**Validation report form for Renewal of Crediting Period of Programme of Activities**

**Gold Standard for Global Goals**

<b>Title and GS reference number of the program of activities (PoA)</b>	GS1247: Improved Kitchen Regimes Multi-Country PoA
<b>Version number of the validation report</b>	3.0
<b>Completion date of the validation report</b>	18/08/2025
<b>Version number of the PoA-DD to which this report applies</b>	17.3 Dated 06/08/2025
<b>Coordinating/managing entity (CME)</b>	CO2balance UK Ltd.
<b>Project Participants and any communities involved</b>	To be mentioned at the VPA level
<b>Host Party</b>	The People’s Republic of Burkina Faso The State of Eritrea The Federal Democratic Republic of Ethiopia The Republic of The Gambia The Republic of Guatemala The Republic of Malawi The Republic of Mozambique The Republic of Sierra Leone The Togolese Republic The Republic of Uganda The Republic of Zambia The Republic of Zimbabwe
<b>Applied methodologies and standardized baselines</b>	GS Technologies and Practices to Displace Decentralized Thermal Energy Consumption (TPDDTEC) v4.0 GS Simplified Methodology for Efficient Cookstoves v3.0

**Documentation provided by project participant**

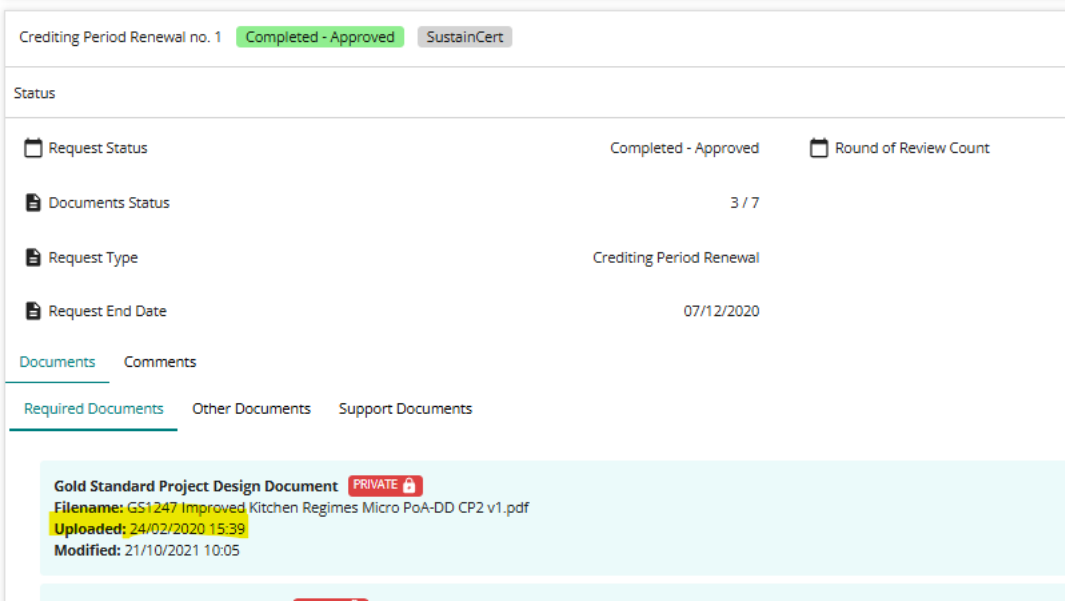
The CME is kindly requested to clarify if the cross-effects for using multiple methodologies under the PoA have been considered. Furthermore, the CME is also kindly requested to clarify if the cross-effects under consideration are in accordance with the “Annex 1- Instruction for consideration of cross-effect for the application of multiple methodologies for PoA” of GS4GG “Programme of Activity Requirements and Procedures v3.0”

The CME is kindly requested to clarify in accordance with the applicability condition 2.3.2 what procedures will be followed in the case that the project lifetime is found to be less than the crediting period.

1. CME has added text into Section B.2.1 explaining that cross effects will not be an issue within this PoA
2. CME has added text into Section B.2.1 table

1. The CME has updated in section B.2.1 that the projects will implement only one methodology, and in case the VPAs do employ different methodologies the cross-effects will be addressed at the VPA level. **Closed**.
2. The CME has revised the section, and it now includes the measures that will be taken within the PoA if the units fail to reach their expected lifetime. The CME will ensure a replacement stove is provided of comparable quality. If no retrofitting or replacement is done the ER claims will be limited to the lifetime of technology. **Closed**
